**RESPONSE TO
JANUARY 24, 1986 NMOCD COMMENTS
DISCHARGE PLAN (GW-32)
FOR GIANT REFINING COMPANY
CINIZA REFINERY**

February 3, 1986

**DAVID BOYER
NEW MEXICO OIL CONSERVATION DIVISION
P.O. Box 2088
State Land Office Building
Santa Fe, New Mexico 87501**

**GIANT REFINING COMPANY
Route 3, Box 7
Gallup, New Mexico 87301**

FIGURE F-1
GIANT REFINING COMPANY
MONTHLY EVAPORATION-POND INSPECTION

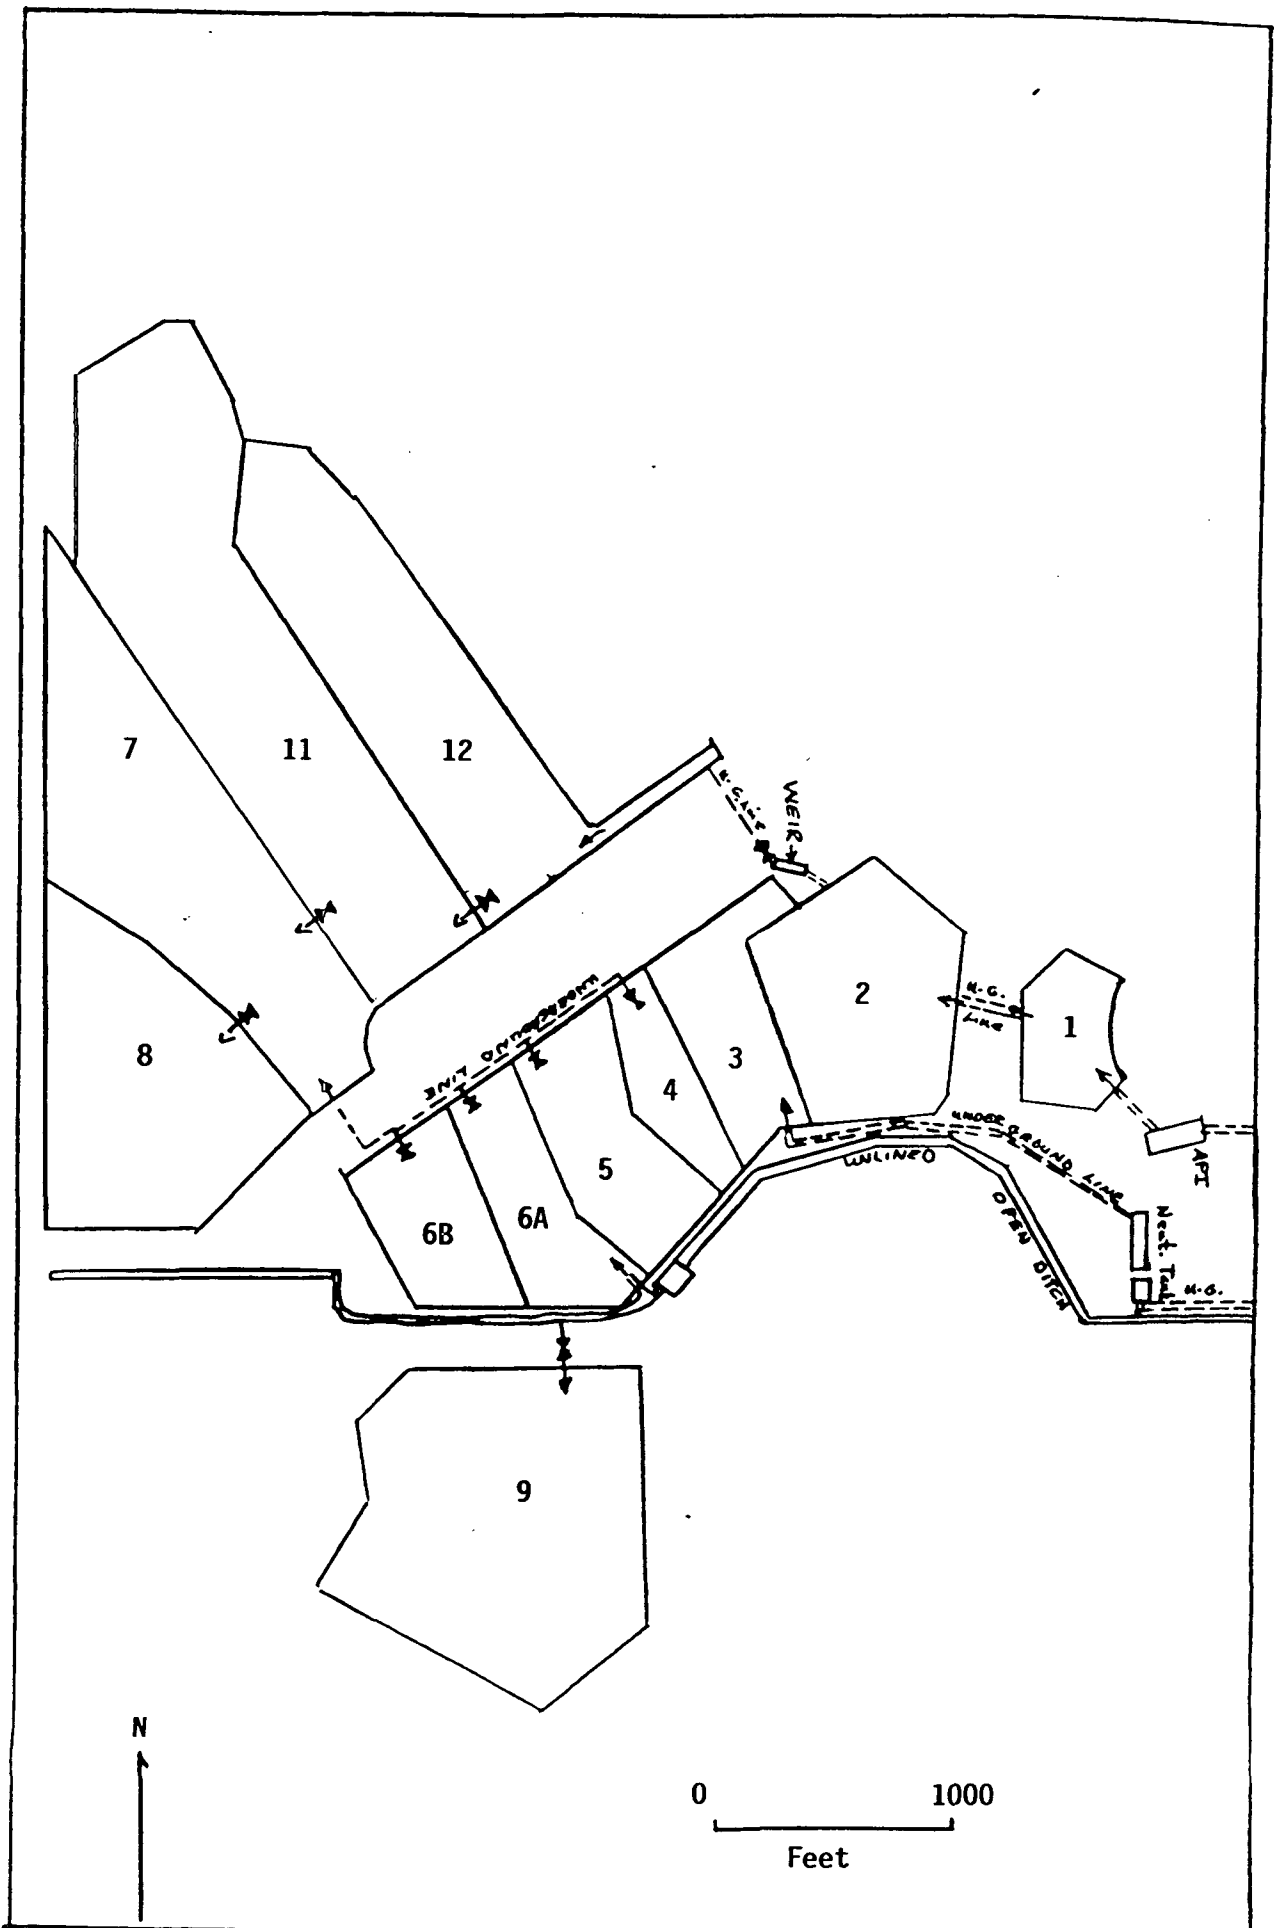
1. A copy of the RCRA Part B permit application Contingency Plan (Attachment E) is included.
2. Figure F-1 is a monthly inspection form. Ponds and berms are inspected informally on a daily basis for water levels and for signs of blockage in conveyances and underdrains. More formal inspection is performed monthly or as soon as possible following a major storm. Monthly inspections include reading of staff gauges, inspection of all roads and berms, and notation of problem areas on the attached map. Areas showing damage or erosion will be promptly repaired.
3. All spills will also be reported to NMOCD. A sludge spill which occurred in August, 1985 was reported to NMEID. A copy of that report is attached (Attachment D).
